Product / Process Change Notification (PCN)

PCN Number: PCN_FeAFB_20250101

Affected Series: WE-AFB

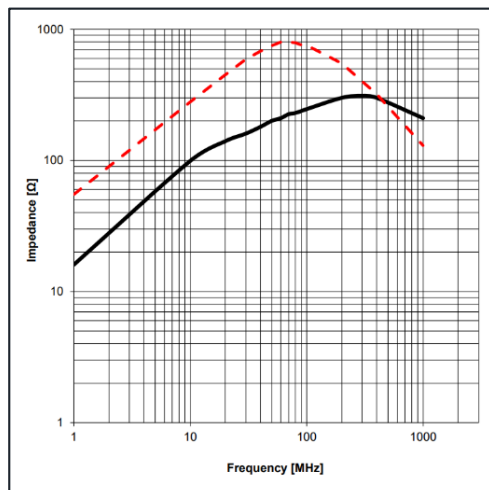
3. The visualization of chart for the “**Typical Impedance Characteristics**” changes. The used type of cable and cable length is shown in each chart.

Before change:

- Showing only one graph with 1 turn (1T) and 2 turns (2T) impedance curves.

- Showing no graph with 3 turns impedance curve.

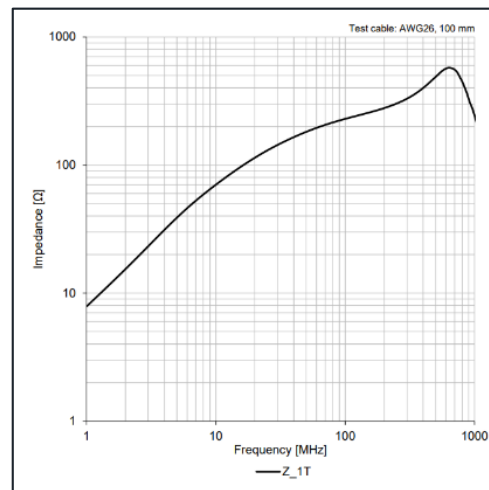
After change:

- Showing a graph for the 1 turn (Z_1T) impedance curve with the shortest possible cable length according to the product.

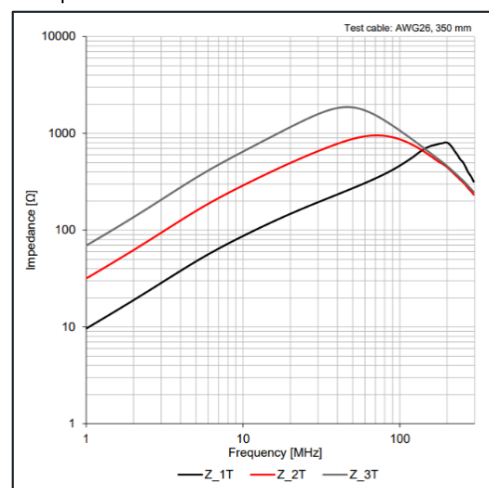
- Showing a graph for 1-3 turns (Z_1T, Z_2T, Z_3T) impedance curves with the shortest possible cable length, which is required for 3 turns according to the product.
